Datakey – Product Change Notification

PCN Number: 20160803-2
Notice Date: 3 August 2016
Notification Subject: SlimLine™ Board-Mount Receptacle Packaging Change

For reference, dimensioned drawings of the old plastic trays and the new plastic trays are shown below.

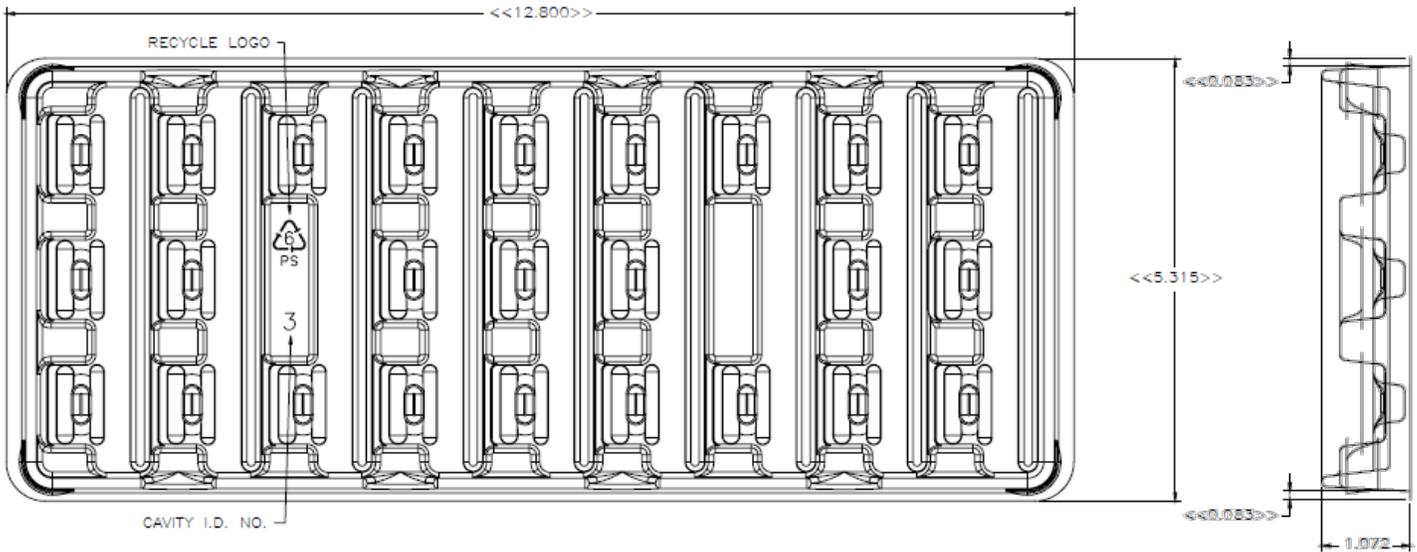
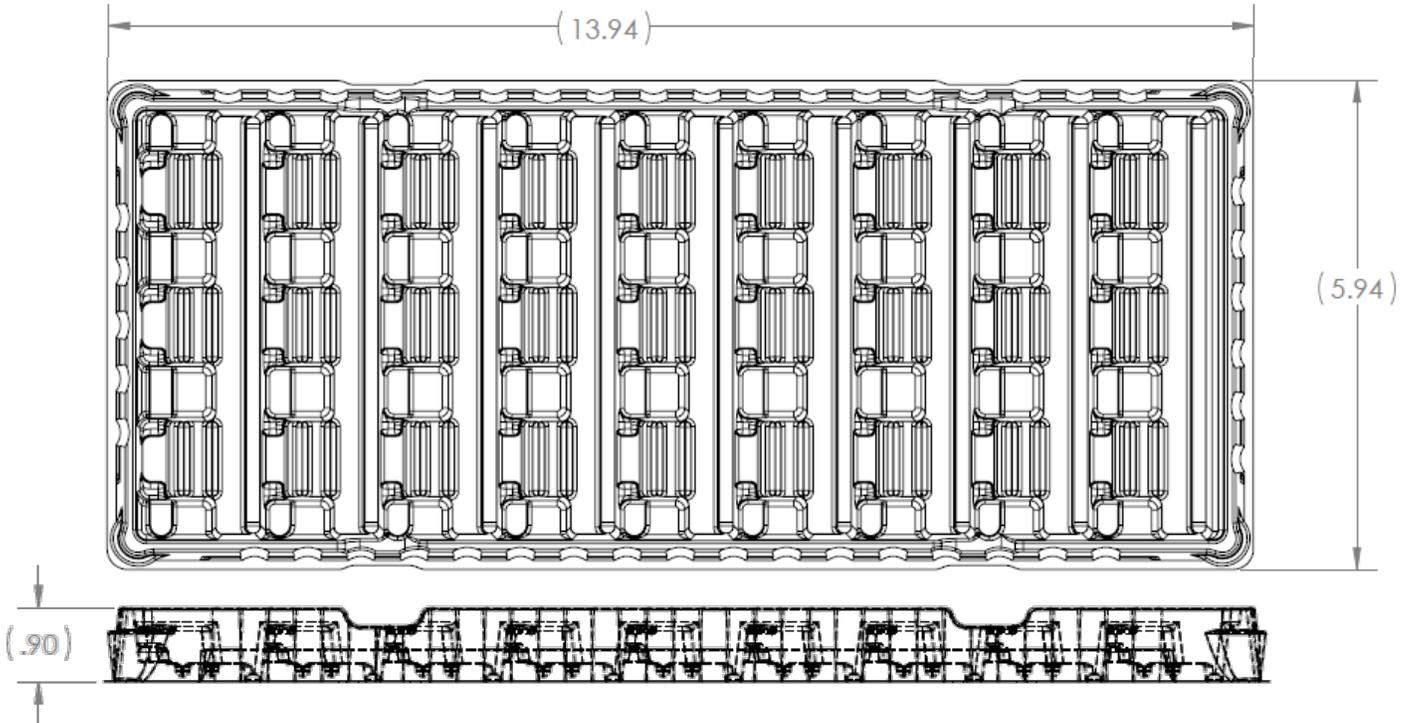
Old Tray - 12.8" x 5.3" x 1.1" (below):

- 25 Receptacles Per Tray
- 9 rows x 3 columns (2 blanks)

New Tray - 13.9" x 5.9" x 2.0" (below):

- 27 Receptacles Per Tray
- 9 rows x 3 columns
